Kansas Department of Agriculture
 Division of Water Resources
CHANGE: P/D WORKSHEET

RE: Water Right,
File Nos. 37,027;
Appropriation of Water,
File No. 49,431

**APPROVAL OF APPLICATION
FOR
CHANGE IN
POINT OF DIVERSION
WATER RIGHT
FILE NO. 49,431**

**APPLICATION FOR APPROVAL TO
CHANGE THE PLACE OF USE, THE
POINT OF DIVERSION OR THE USE
MADE OF THE WATER UNDER AN
EXISTING WATER RIGHT**

Change in Point of Diversion

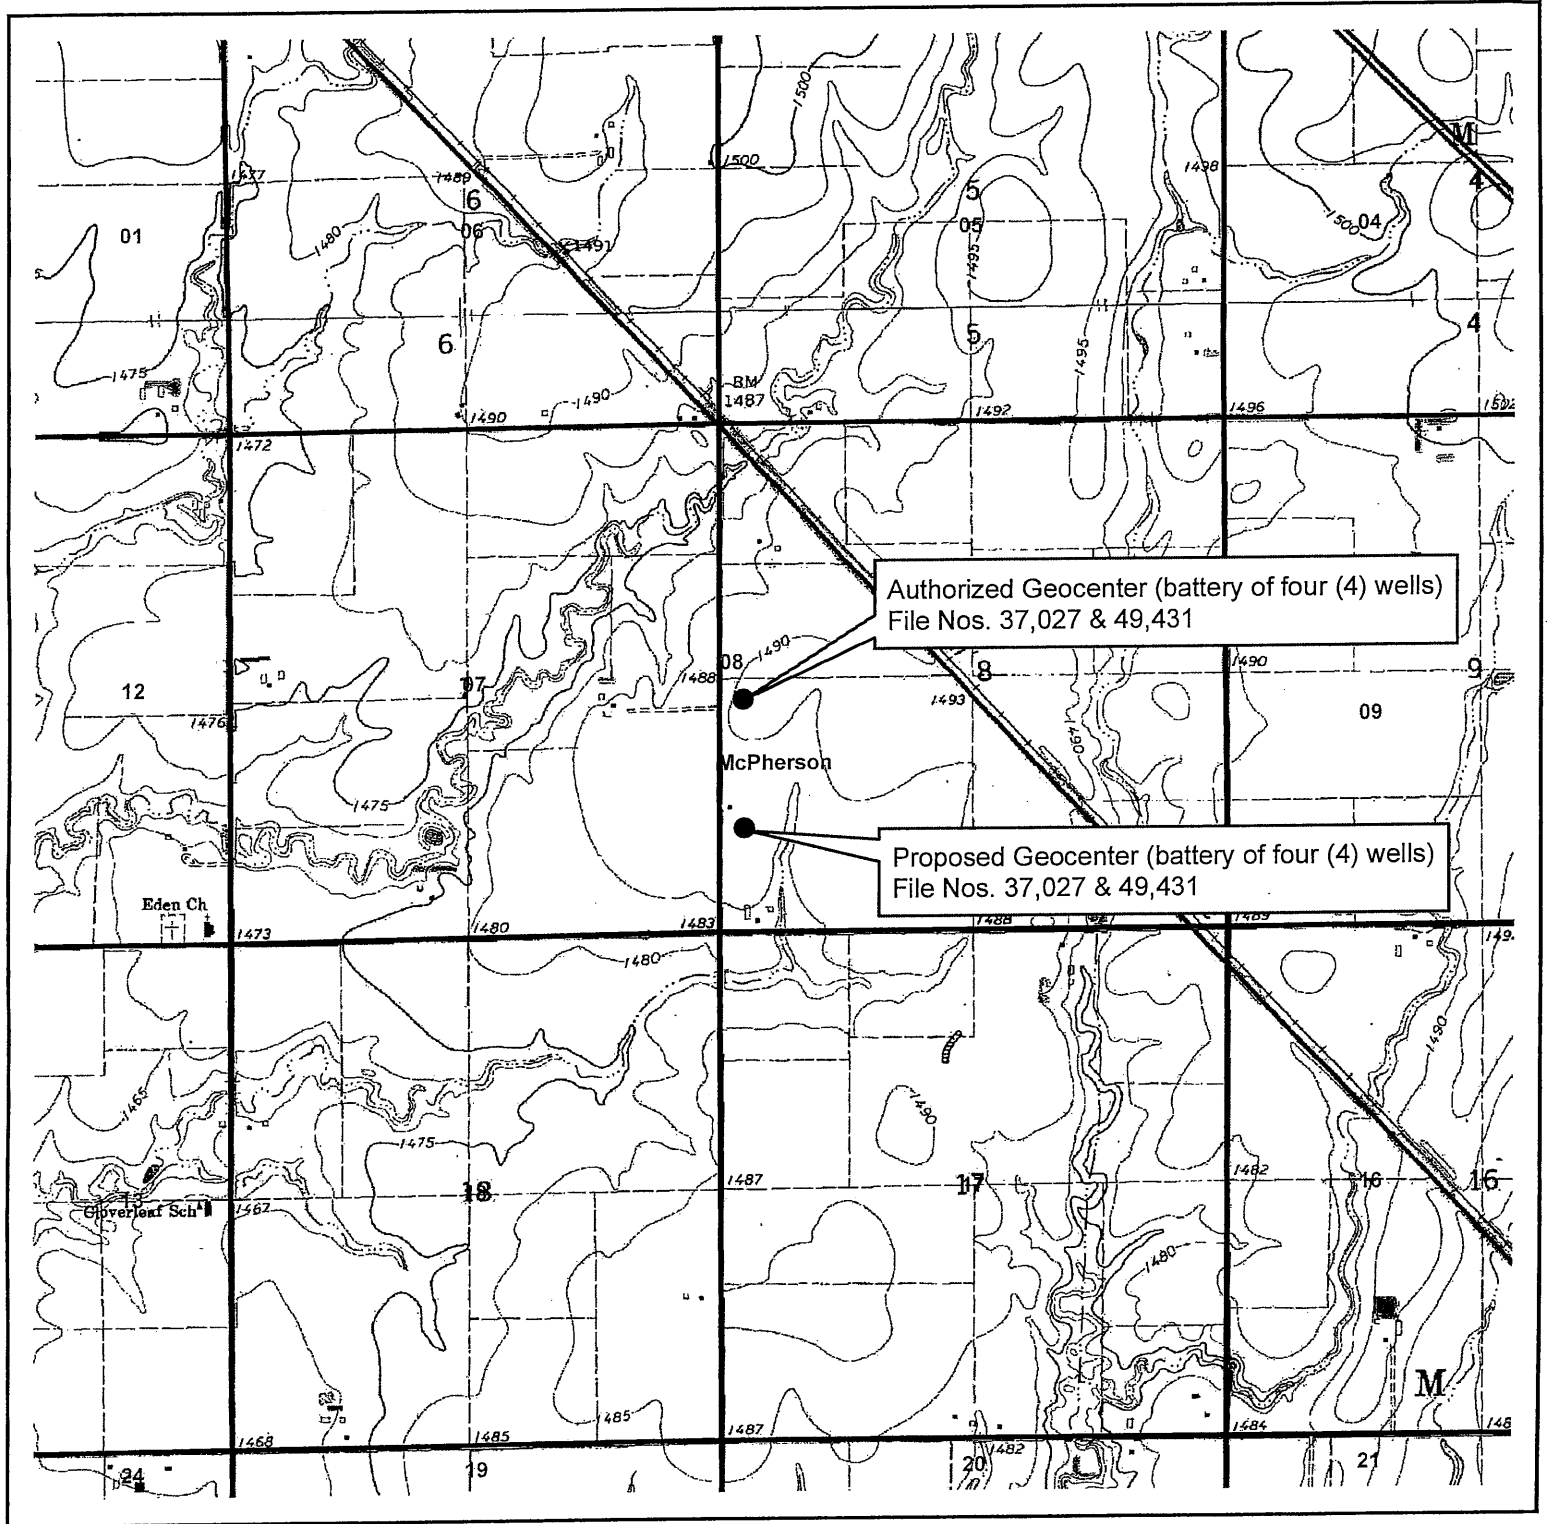
Water Right, File No. 37,027 is authorized 19 acre-feet at a diversion rate of 220 gallons per minute, Appropriation of Water, File No. 49,431 is authorized and limited to 94.9 acre-feet at a diversion rate of 800 gallons per minute when combined with File No. 37,027 for irrigation use on 73 acres located in Sections 8, Township 21 South, Range 2 West, McPherson County, Kansas. Both files have the same authorized point of diversion and place of use. The application proposes to move the battery of four (4) wells, that has not yet been drilled, south by 1,380 feet.

The proposed change meets the well spacing as detailed in K.A.R. 5-4-4 (d). There are no other appropriated wells within 1,320 feet, nor domestic wells reported within 660 feet of the proposed geographical center of the battery of wells. Therefore, the change complies with well spacing requirements.

The effective date of the change shall be the date this order is executed by the Chief Engineer, after which the authorized location of the point of diversion shall be:

one (1) battery of four (4) wells with a geographic center located in the Northwest Quarter of the Northwest Quarter of the Southwest Quarter (NW $\frac{1}{4}$ NW $\frac{1}{4}$ SW $\frac{1}{4}$) of Section 8, more particularly described as being near a point 1,050 feet North and 5,040 feet West of the Southeast corner of said section, in Township 21 South, Range 2 West, McPherson County, Kansas,

located substantially as shown on the map accompanying the application to change the point of diversion

Change in Point of Diversion
Water Right, File Nos. 37,027 & 49,431 WATER RESOURCES RECEIVED JUL 22 2016

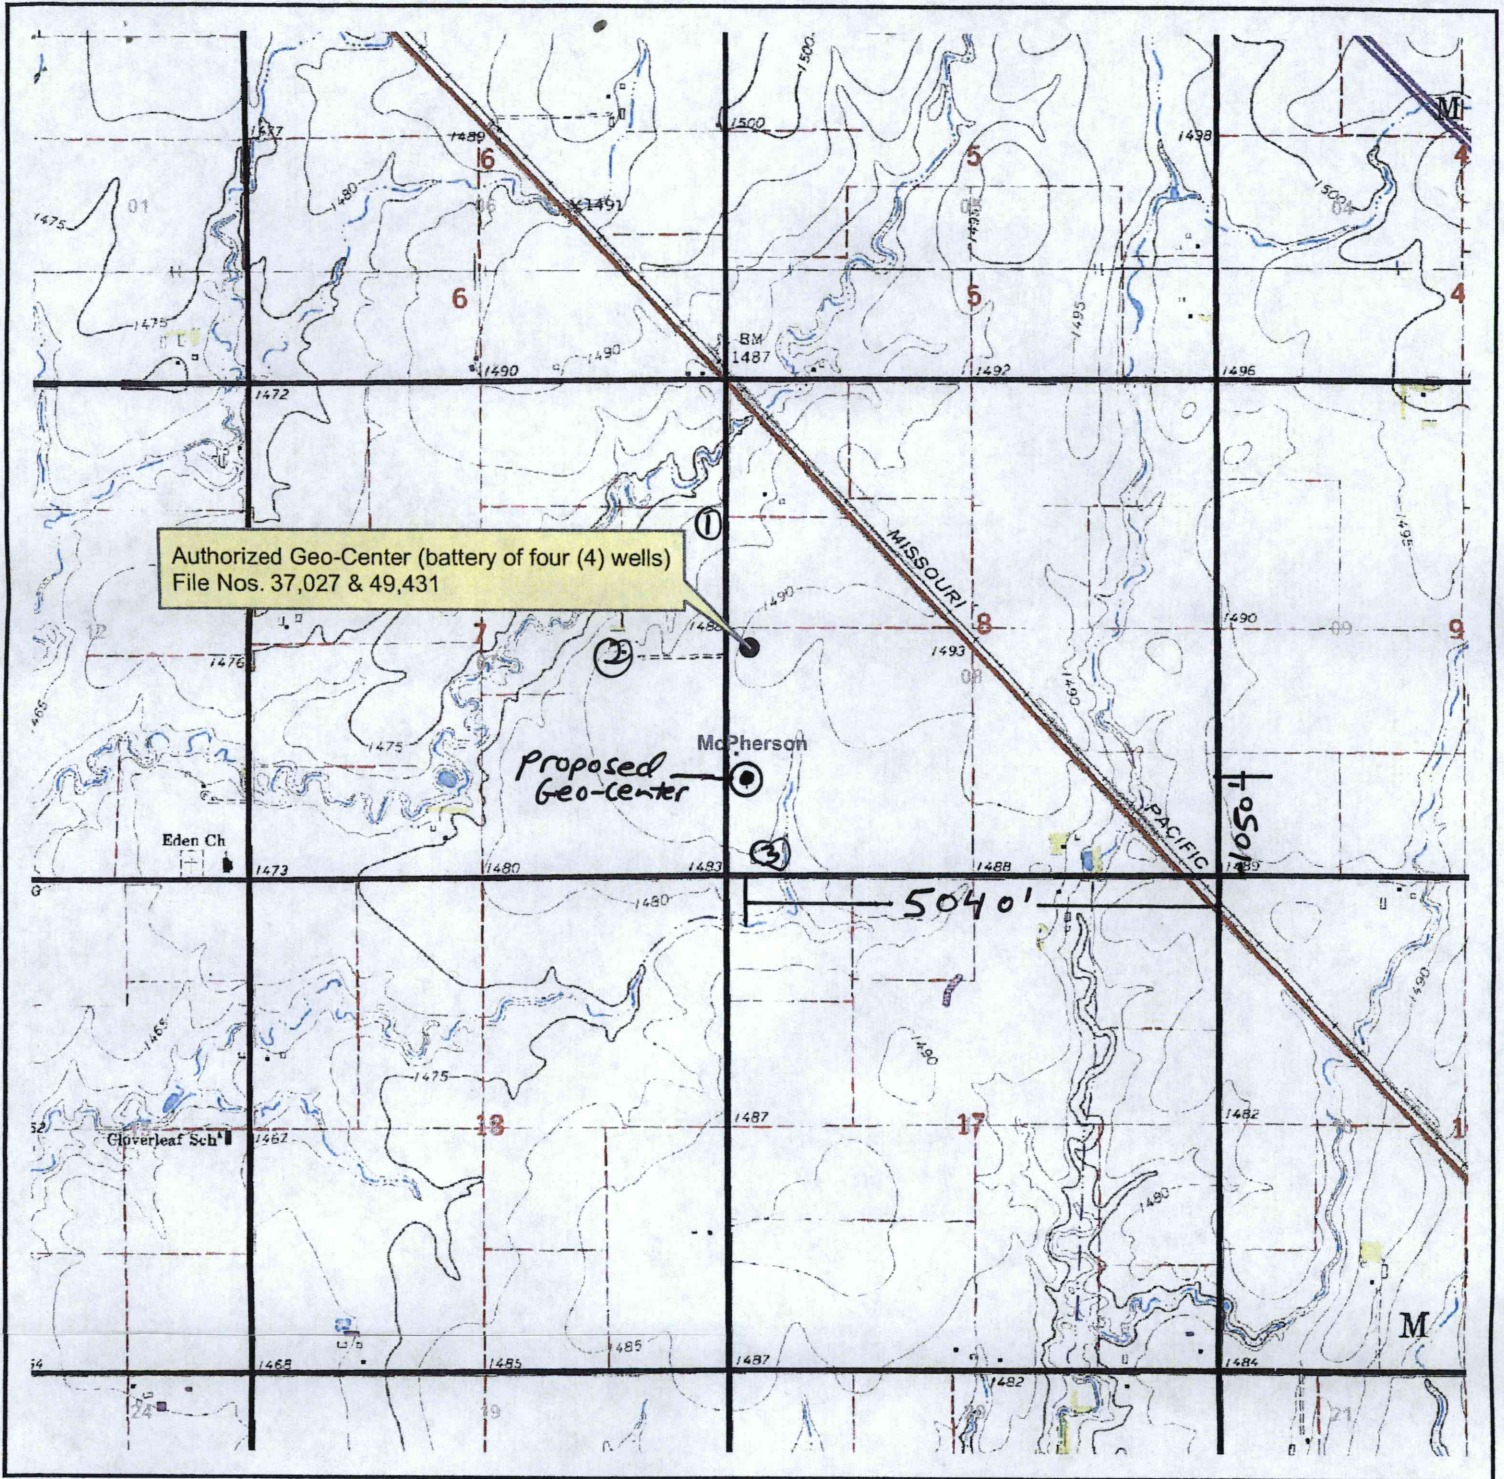
It appears that all nearby wells were notified of the proposed change. Spacing to the geo-center is met with regard to all nearby irrigation and domestic wells (the furthest SE well of the battery likely is within 660' of the owners domestic well (~630')). A rough location map is attached.
